Service Bulletin

Bulletin No.: 20-NA-003

Subject: Service Driver Assist Message Illuminated, Front Seat Lane Departure Warning Actuator Inoperative, DTC B172E Set

Brand:	Model:	Model Year:		VIN:		Engine:	Transmission:
		from	to	from	to		
Buick	Envision	2016	2019			All	All

4283098

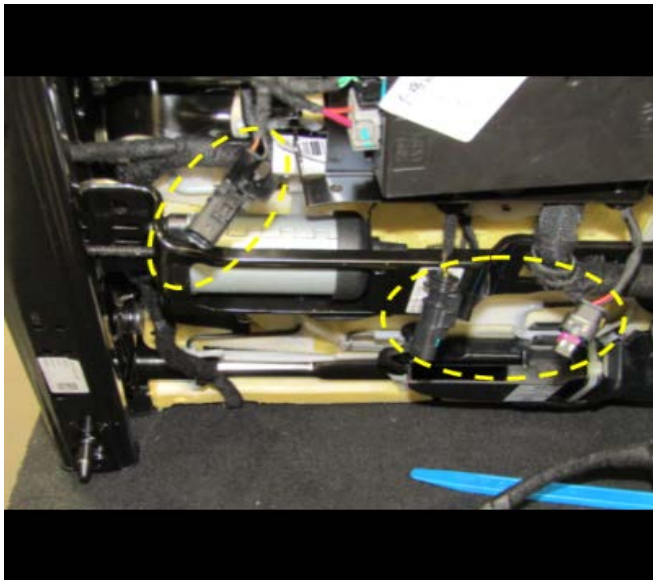
1. Replace the TWO front seat lane departure warning actuators (2). Refer to Front Seat Lane Departure Warning Actuator Replacement, in SI.

5479756

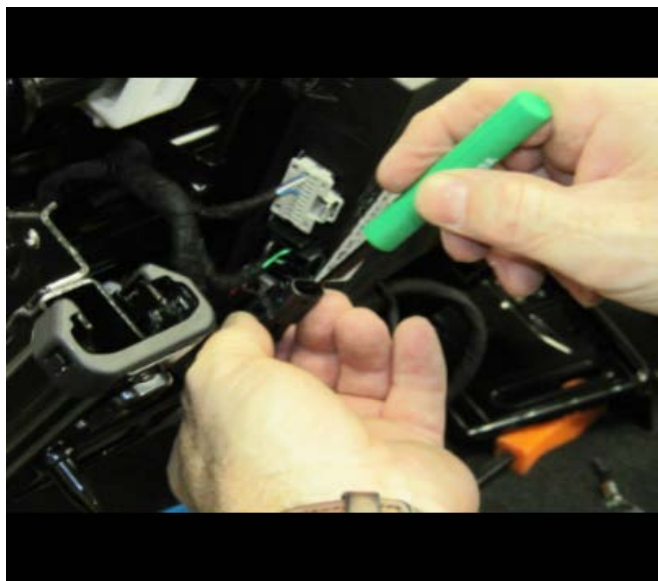
Note: The harness rework is a swapping of the terminal polarity on the actuator connectors (shown circled above). Ensure to complete the rework BEFORE reassembly of the seat.

2. Rework the actuator harness, following the steps below.

5479758

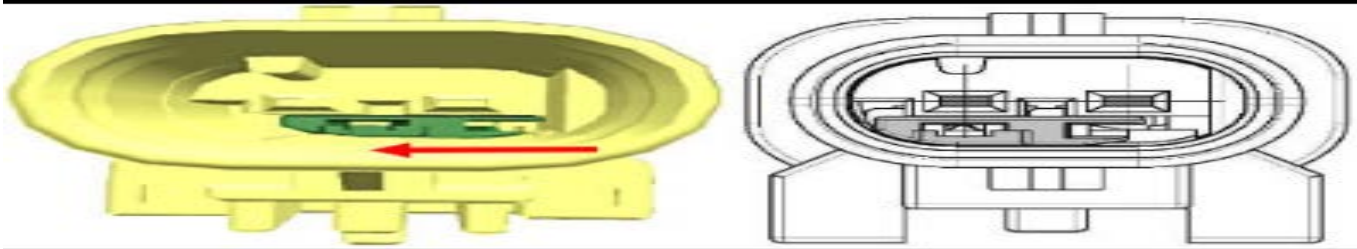
2.2. Using the removal tool # J-38125-12A, unlock the connector by moving the retainer to the pre-lock position, as shown above.

5479760

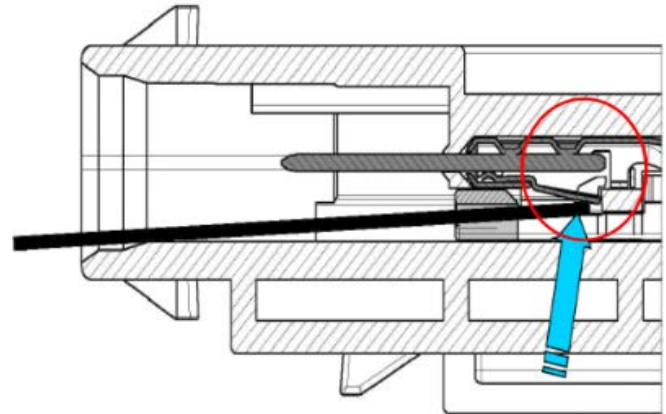
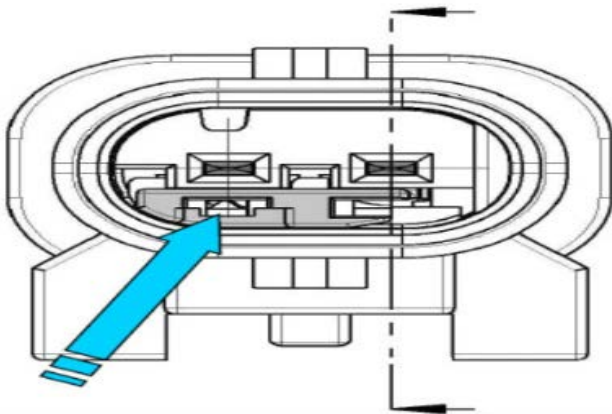
2.4. Push the terminal spring and pull the wire.

Note: Remove the terminals one at time.

2.3. Insert the removal tool through the GAP, at blue arrow.

5479761

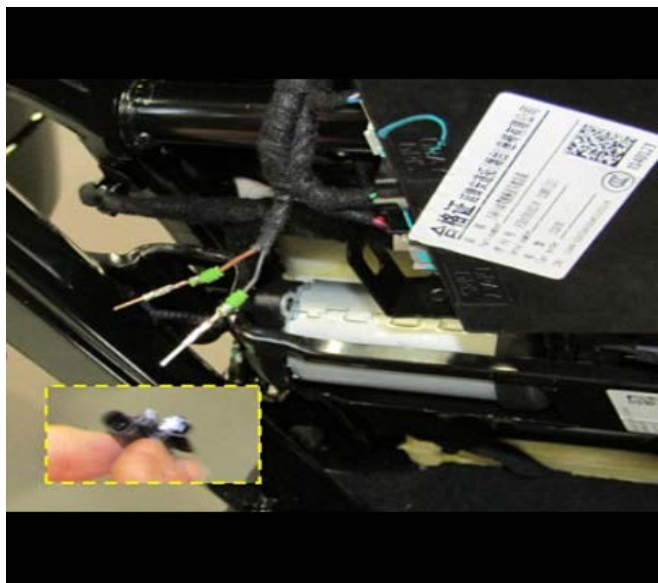
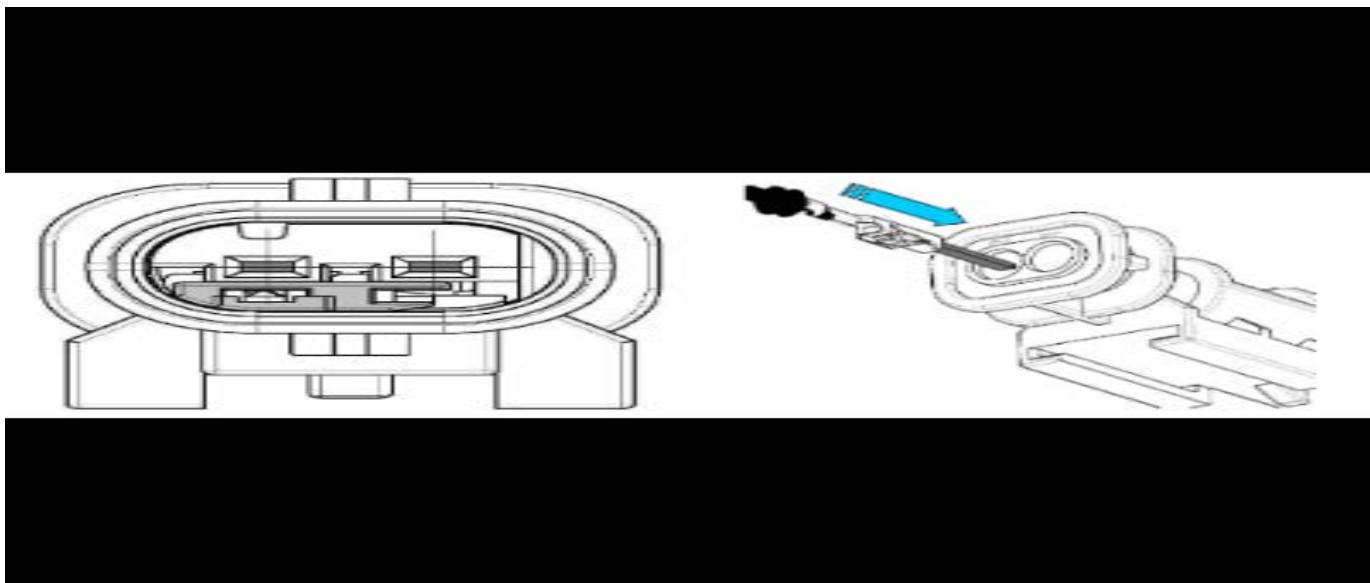
2.5. Swap the terminals from the actuator harness connectors on both sides.

Original Polarity Before Rework		Polarity Reversed After Rework	
Cavity	Wire Color	Cavity	Wire Color
1	Yellow/Black	1	Black
2	Black	2	Yellow/Black

Original Polarity Before Rework		Polarity Reversed After Rework	
Cavity	Wire Color	Cavity	Wire Color
1	Brown	1	Black
2	Black	2	Brown

5479858

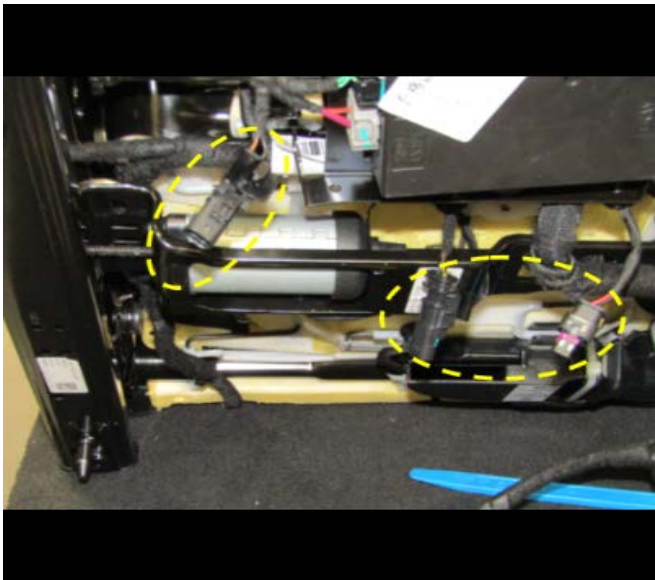
2.6. For assembly of the terminals, with the retainer in pre-lock position, move the terminal in the direction shown above, until the terminal locks.
